INTER-OFFICE CORRESPONDENCE
RECOMMENDATION FORM

RE: Assisted Living Facility (Class "A").

ZONING USE PERMIT PLAN FOR CLASS A' ASSISTED LIVING FACILITY

LOCATED AT: 5947 CENTRAL AVE. BALTIMORE COUNTY, MD. 21207 ELEC. DIST. 1ST PROPERTY OWNER: TRACEY L. TURNAGE ADDRESS: 5947 CENTRAL AVE. BALTIMORE COUNTY, MD. 21207 PLAN DATE 6/1/2000 PHONE NO# 410-869-0756 LOT SIZE = 6,316 SQ. FT. OR .145 ACT. ZONING MAP: SW 5F ZONE DR 5.5

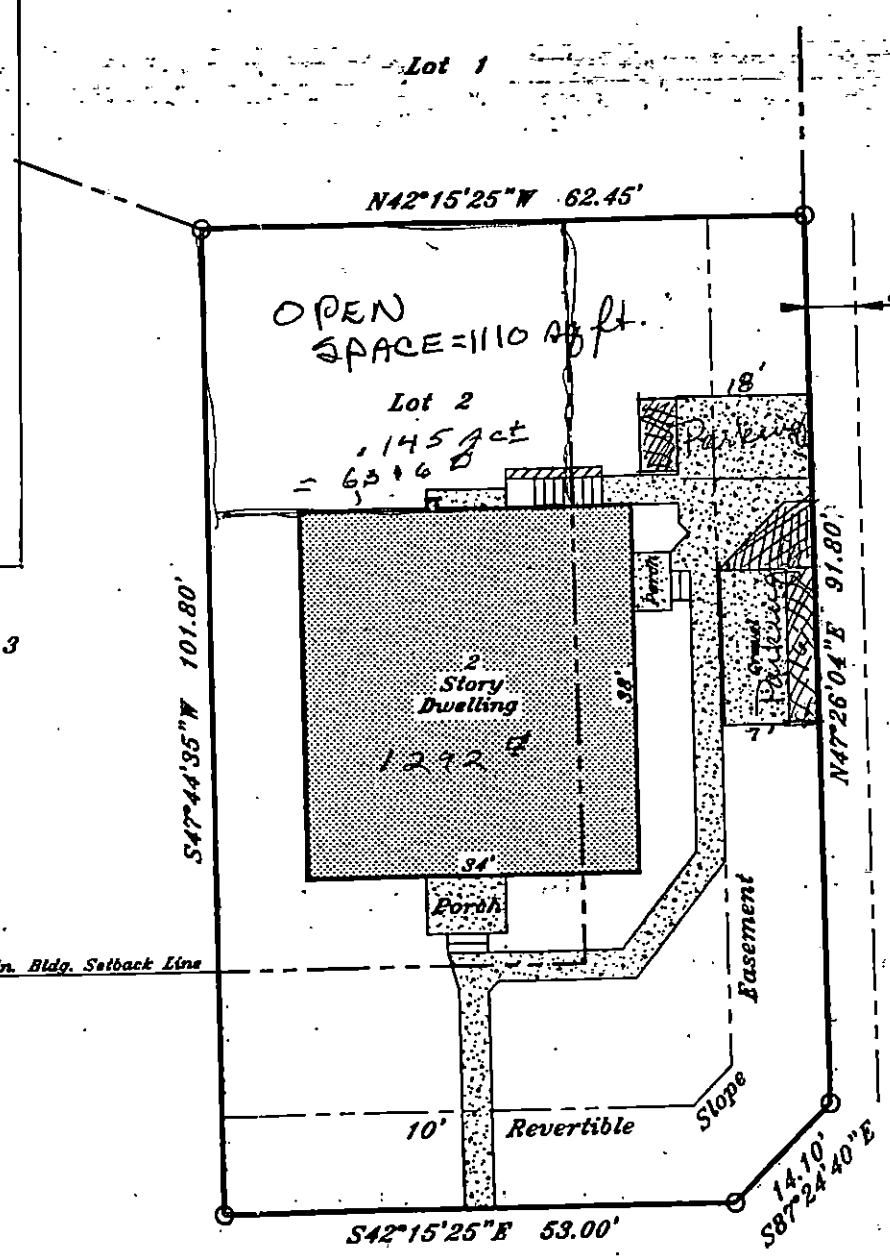
The applicant must demonstrate Full compliance with all ADA requirements prior to the issuance of any permits.
